2025 GROUP B PROPOSED CHANGES TO THE I-CODES

April 27 – May 6, 2025
Doubletree by Hilton
Universal Orlando - Orlando, FL

Publication Date: March 2025

FIGURE R610.8 R610.5.3 TYPICAL SIP WALL PANEL-TO-PANEL CONNECTION DETAILS

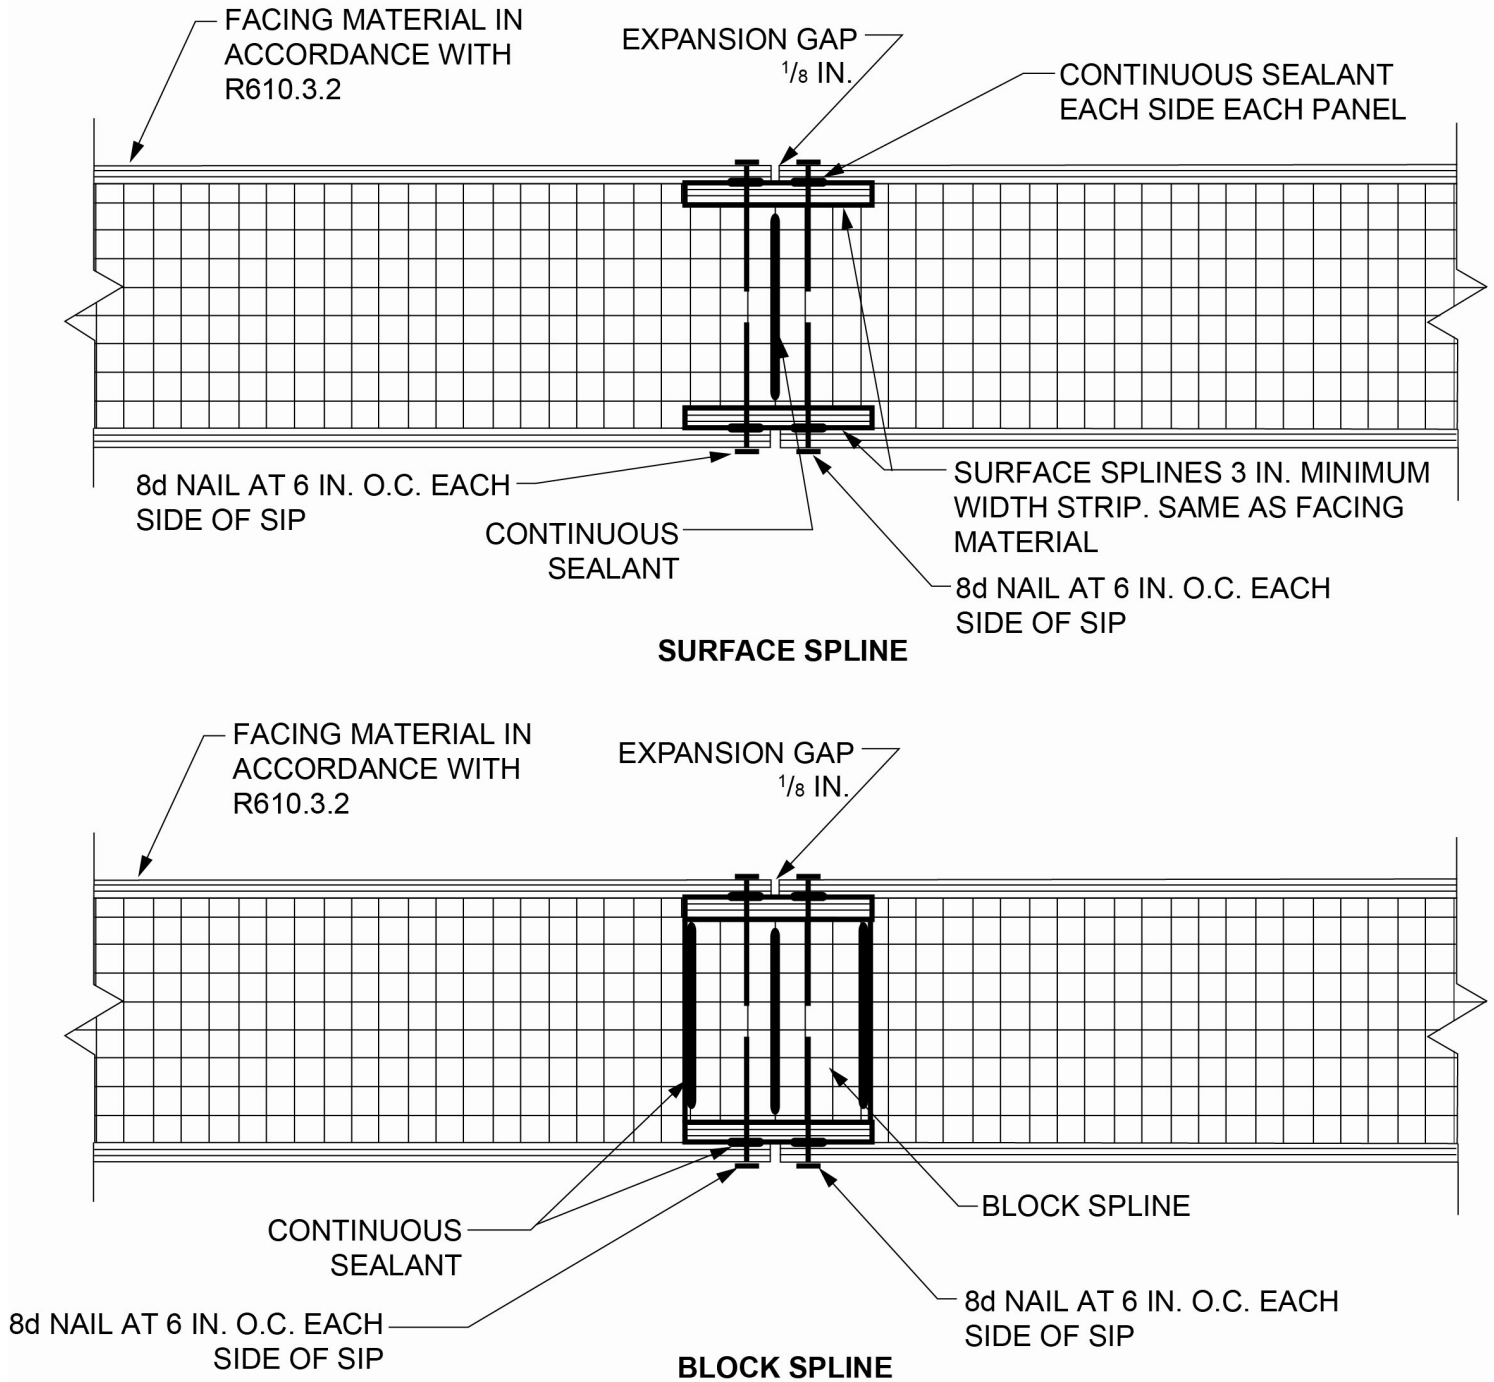
R610.5.3 Panel-to-panel connection. SIPs shall be connected at vertical in-plane joints in accordance with Figure R610.5.3 ~~R610.8~~ or by other *approved* methods.

Reason: For the 2018 IBC, code change proposal RB217-16 added new text as follows: "R610.5.3 Panel-to-panel connection. SIPs shall be connected at vertical in-plane joints in accordance with Figure R610.8 or by other approved methods." The original proposal did not renumber "Figure R610.8" to "Figure R610.5.3". Section R610.8 does not reference current Figure R610.8, thus Figure R610.8 should be renumbered R610.5.3 to correlate with Section R610.5.3. The original 2016 Group B Report of the Committee Action Hearings and IRC Public Comment Agenda are located:
